PLAN
OF
LOCKWOOD STREET

by
Schubart & Haines

Providence Dec 27.th
1850

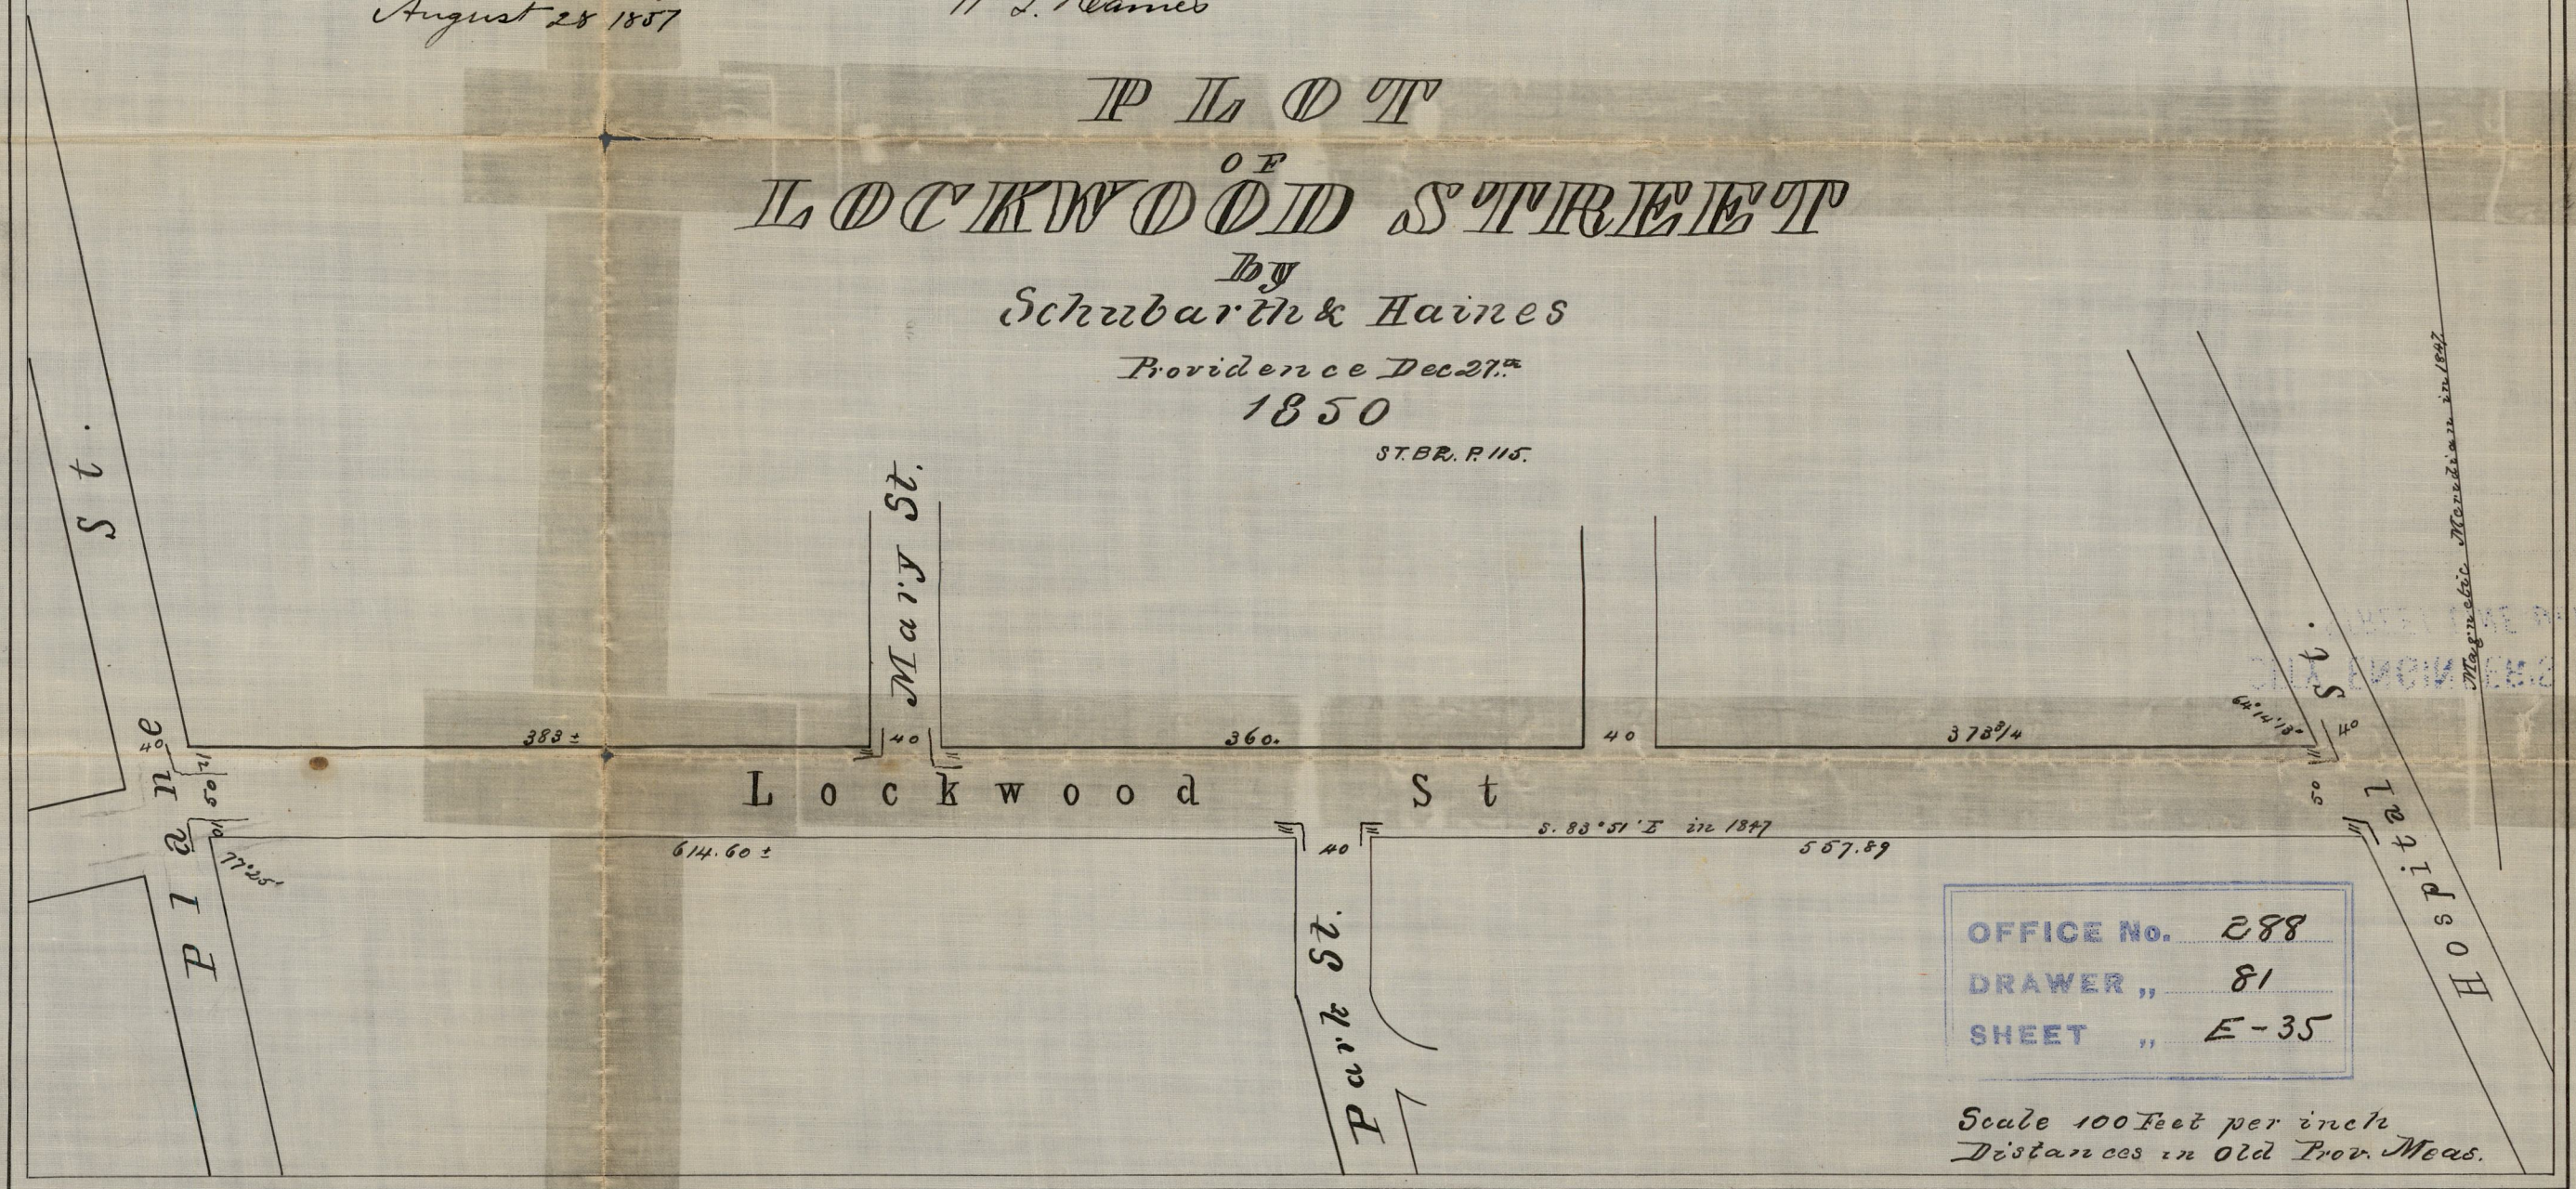
Note the grade cuts at the intersection of curbstone on Lockwood
and the East side of Plane Street, were set 1 foot too
far South, by mistake - The cuts at Mary and Park Streets
and thence Eastward to Hospital Street were set right
viz. 11 ft. from the line of the Street
Wm. Haines
August 28 1857
